Service Bulletin No: 51-001

ATA Chapter: 51

AIRCRAFT STRUCTURE - GENERAL**DO A CHECK OF THE MATERIAL SPECIFICATION USED DURING MANUFACTURE AND, IF NECESSARY, DO A CHECK FOR CRACKS OR REPLACE THE PART****1. Planning Information****A. Effectivity**

Replacement of the Bearing on the Forward Control Column
Figure 14

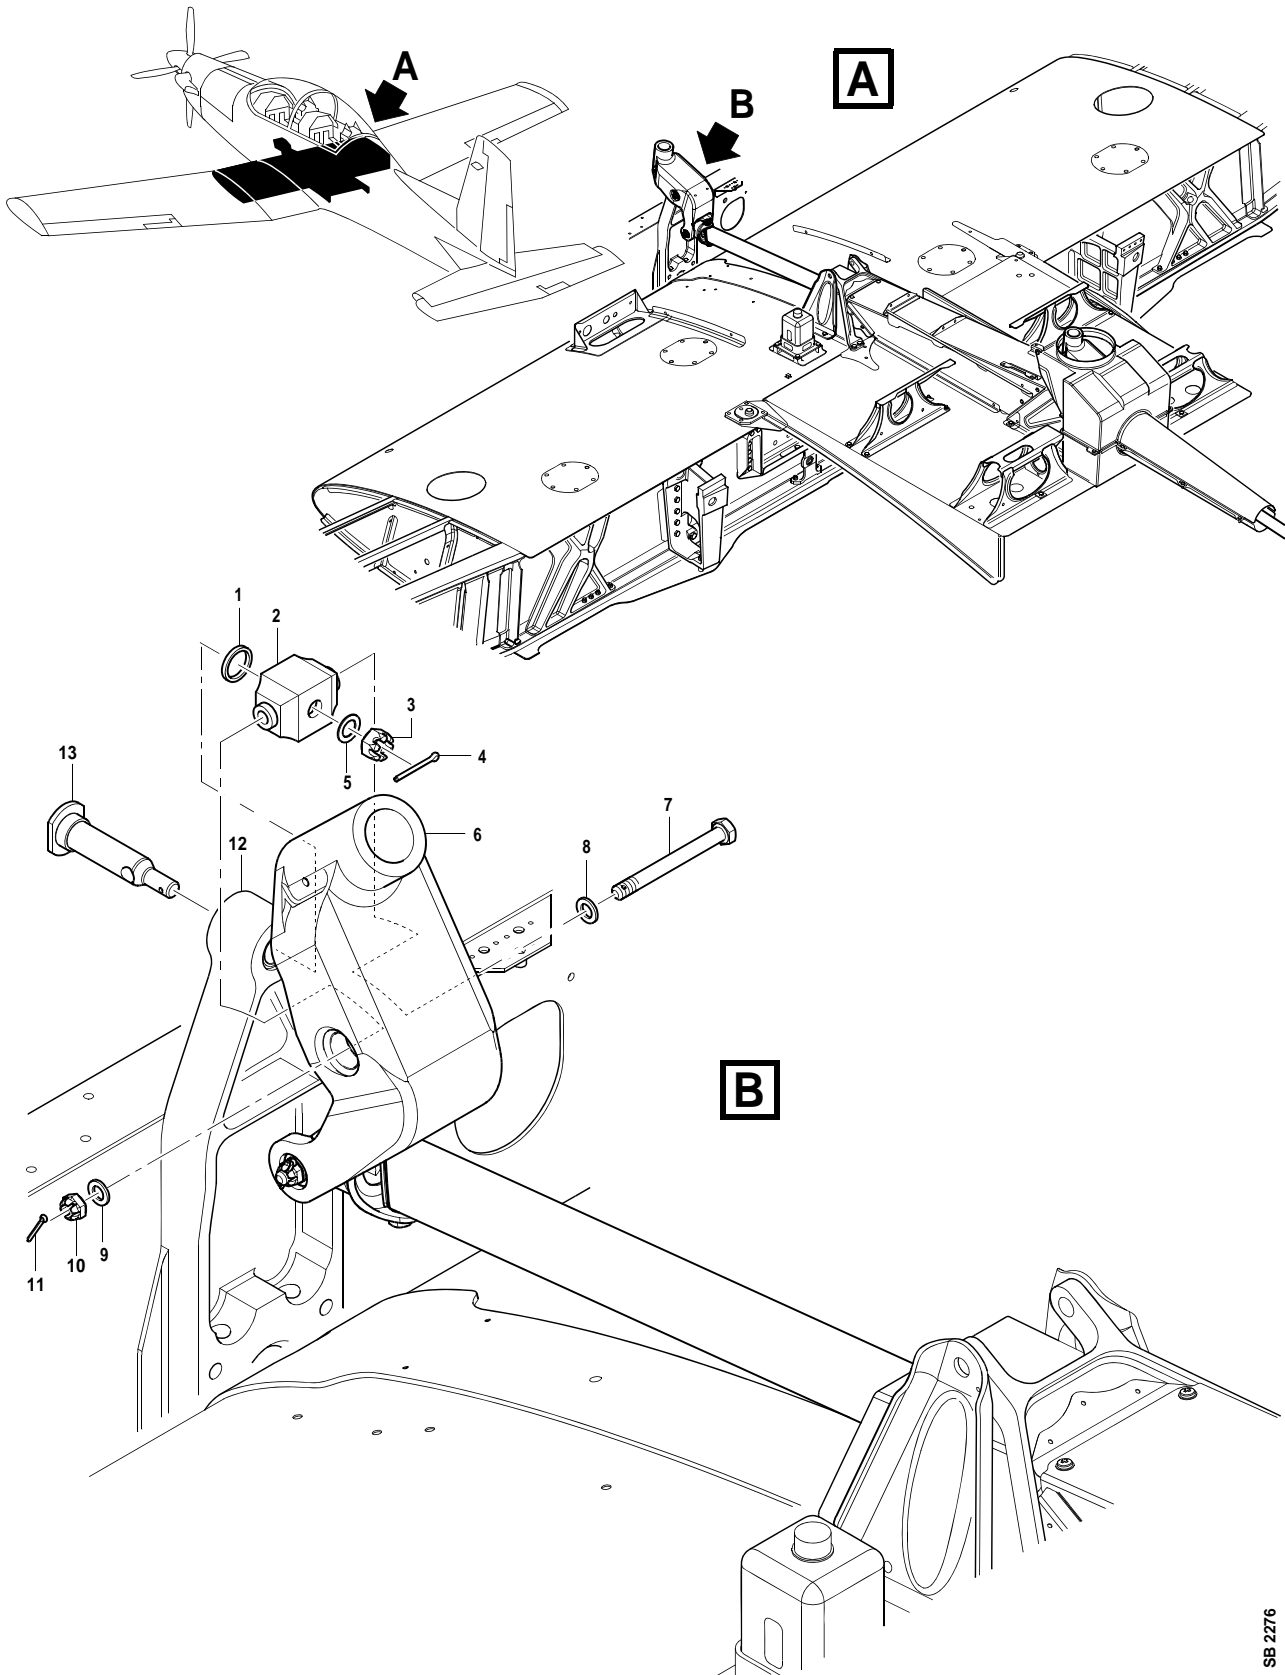
(d) Replace the bearing assembly (Ref. Fig. 14):

- 1 Remove, and discard, the cotter pin (11).
- 2 Remove the nut (10), the washer (9), the washer (8) (if installed) and the bolt (7).
- 3 Move the control lever assembly (6) towards the rear of the aircraft to get access to the bearing assembly (2).

- 4 Remove, and discard, the cotter pin (4).
- 5 Remove the nut (3), the washer (5), the special washer (1) and the special bolt (13) from the rear control-column support bearing assembly (12).

- 6 Remove, and discard, the bearing assembly (2) from the aircraft.
- 7 Put the new bearing assembly (2) (P/N 527.30.09.221) in position in the aircraft.

Inspection and, if necessary, Replacement of the Shackles on the Elevator Control Cable
Figure 15

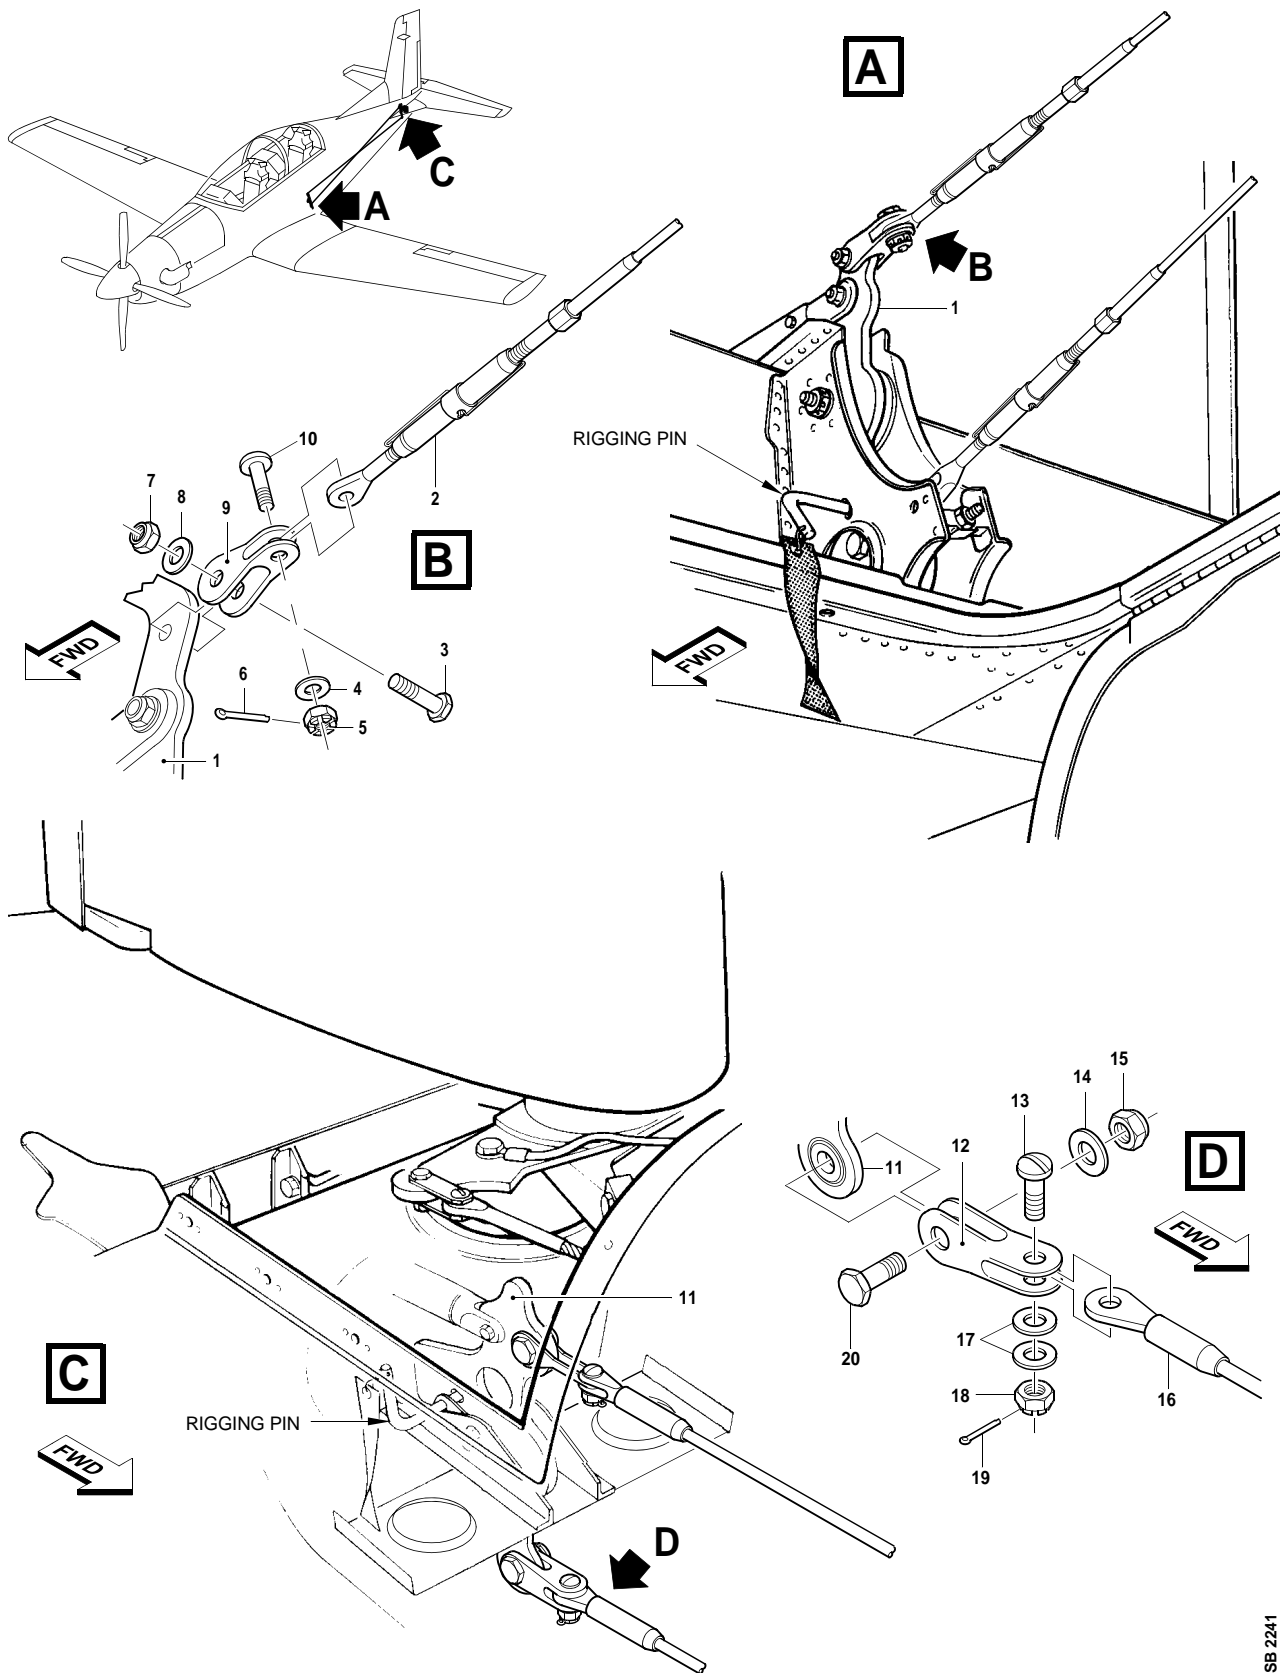
- 3 At the front lever, identify the control cable (2) (P/N 527.30.09.005).
- 4 Remove and discard the locking clips from the turnbuckles (Refer to AMM, 27-20-02 for further information).

- 5 Loosen the turnbuckles to release the tension from the control cable (2) (P/N 527.30.09.005).
- 6 Remove, and discard, the cotter pin (6).
- 7 Remove the nut (5), the washer (4) and the bolt (10) that connect the shackle (9) to the control cable (2).

- 8 Remove the nut (7), the washer (8) and the bolt (3) that connect the shackle (9) to the lever (1).
- 9 Remove, and discard, the shackle (9) from the aircraft.

- 3 At the rear lever (11), identify the control cable (16) (P/N 527.30.09.005).
 - 4 Remove and discard the locking clips from the turnbuckles (Refer to AMM, 27-20-02 for further information).

- 5 Loosen the turnbuckles to release the tension from the control cable (16) (P/N 527.30.09.005).
 - 6 Remove the nut (15), the washer (14) and the bolt (20) that connect the shackle (12) to the lever (11).

- 7 Remove, and discard, the cotter pin (19).
 - 8 Remove the nut (18), the washers (17) and the bolt (13) that connect the shackle (12) to the control cable (16).
NOTE: Pull the control cable (16) rearwards to make the removal of bolt (13) easier.

- 9 Remove, and discard, the shackle (12) from the aircraft.
 - 10 Use the absorbent paper (Material No. P02-031) made moist with the solvent (Material No. P01-010) and clean the attachment points on the lever (11) and the cable (16).
